PLANNING REPORT

MINISTERIAL PLANNING REFERRAL

Application number:	TPM-2014-24/B
DELWP Application number:	2014/002657-1
Applicant / Owner / Architect:	Gurner TM
Address:	334-344 City Road, SOUTH BANK
Proposal:	Amend Planning Permit 2014002657-1 to replace serviced apartments with dwellings, use of the land for a restricted recreation facility (gym) and increase in overall building height
Cost of works:	\$97,000,000
Date received by City of Melbourne:	17 September 2021
Responsible officer:	Xavier LIVY
Report Date:	7 December 2021

Figure 13: Approved and amended tower envelope with associated setbacks (Source: Applicant)

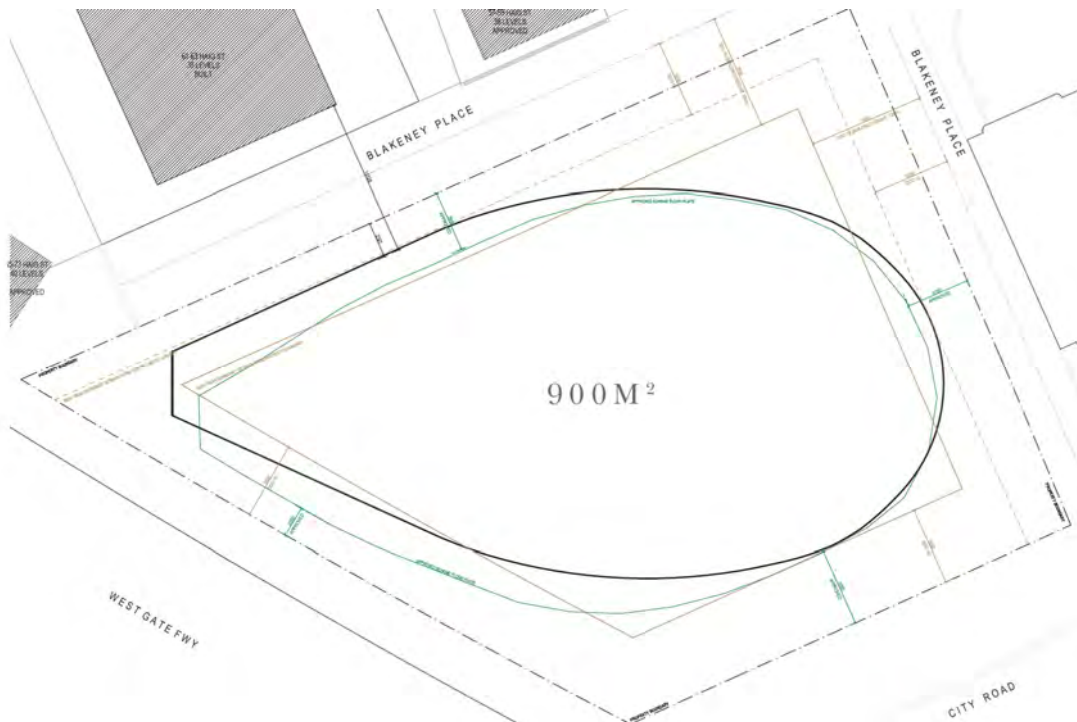
To the north and east, the site adjoins a laneway. The proposed setbacks from the centreline of this laneway are 5.00 metres, compliant with the Modified setback requirements of DDO10, provided the tower floorplate requirement is met (see below).

<p><i>Assessment:</i></p> <p>The endorsed tower floorplate area is 900 m². As can be seen in the Figure 13 above, this is greater than the tower floorplate area allowed under DDO10, which would be in</p>

Figure 14: Existing and proposed arrangement for SM0199 (Source: Applicant)

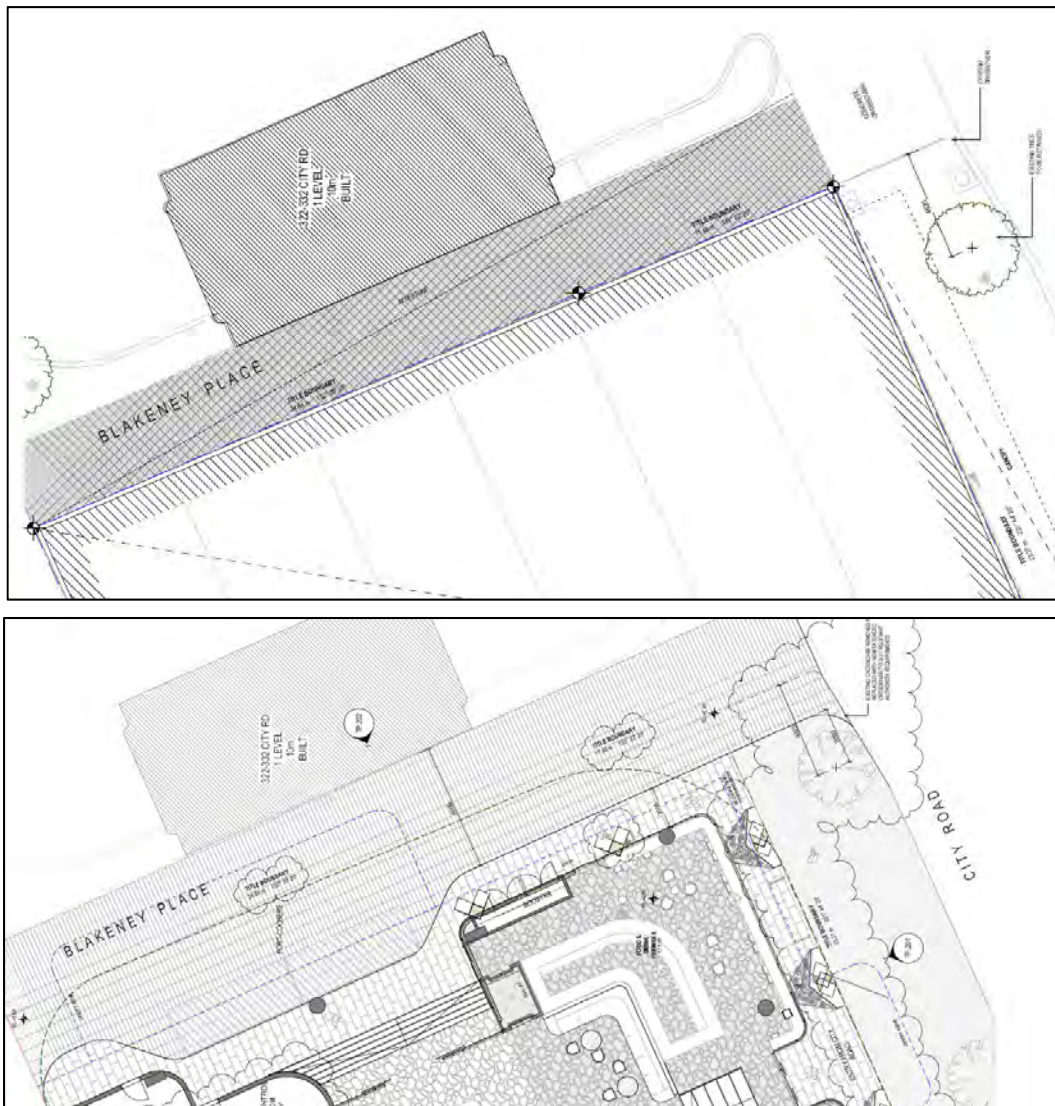
The proposed development plans shows a widening of a Council Lane known as SM0199. The applicant now seeks to provide Public Access as opposed to vesting. Therefore existing Condition 3 would need to be amended as follows:

The proposed plans incorrectly refer to Council Lane SM0199 as Blakeney Place.

Reference to Blakeney Place will need to be deleted from the plans for this portion of the lane.

The application proposes to provide a public benefit in the form of publicly accessible open area on the site, created through the widening of SM0199 from 4.1 m to 6 m.

It is noted that, whilst support for the widening of SM0199 Lane has been provided by Council Infrastructure and Assets, the widened portion of the laneway will remain the Responsibility of the land owner in perpetuity. This arrangement will be secured by a condition requiring a Section 173 Agreement.

- k) Electric vehicle charging infrastructure must be provided in the car park to the satisfaction of the Responsible Authority.
- l) Laneway SM0199 to be correctly referenced in lieu of Blakeney Place on all plans;
